MEMORANDUM

SUBJECT: **BZA Case 18654** – Expedited review requested pursuant to § 3118 for special exception relief in accordance with § 223 for deck additions to a two-story flat at 4008 3rd Street NW

Figure 1

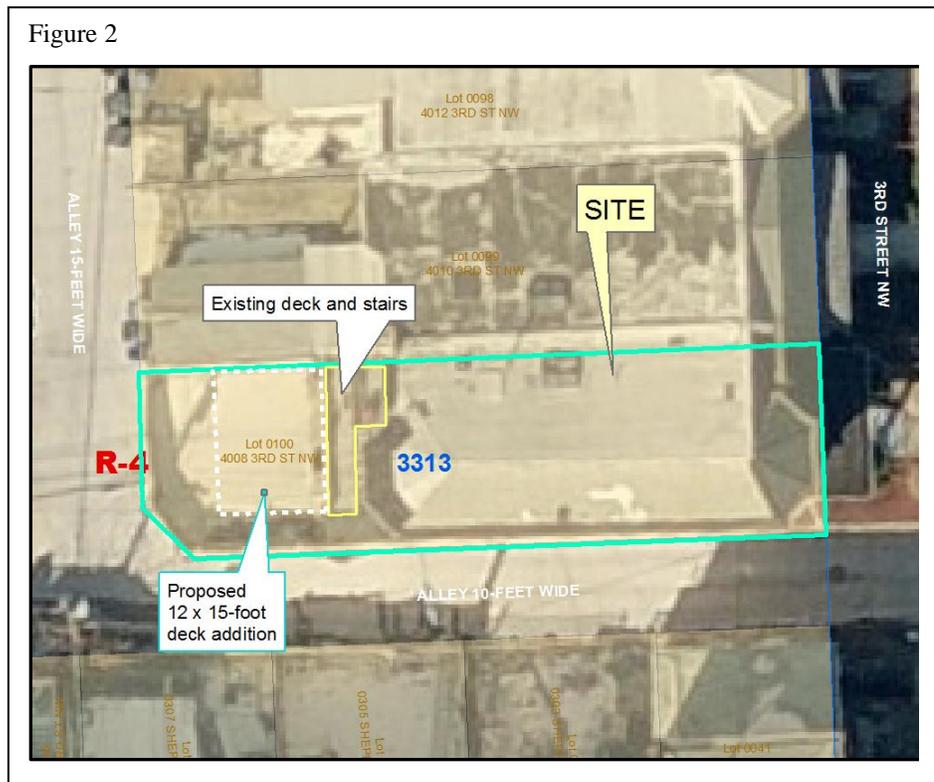
Views from the proposed deck and stair construction toward the neighboring properties would not be substantially different from what current exists. As a result,

OP does not anticipate that the privacy of use and enjoyment of neighboring properties would be unduly compromised.

The proposed addition, as viewed from the street, would not visually intrude upon the character, scale, and pattern of houses along the street frontage.
